NO. SI 40NG-061

Austro Engine Mandatory Service Bulletin No. MSB-E4-022/1
ATA-Code: 71-00

MANDATORY SERVICE BULLETIN

No. MSB-E4-022/1
SUPERSEDES MSB-E4-022

Figure 4: Waste Gate Circlip

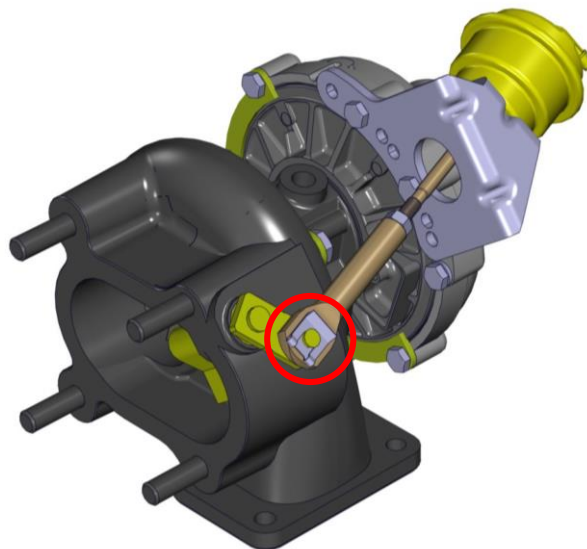
3. For waste gate controllers with markings as identified under 2. replace the waste gate controller with a waste gate controller not marked as listed under 2. according to Maintenance Manual section 81-00-33.
4. If MSB-E4-024/1 or RSB-E4-024 is not installed, replace the circlip DIN6799-5 with the spring loaded circlip E4A-41-100-801. For removal and installation refer to Maintenance Manual E4.08.04. Refer also to figure 4
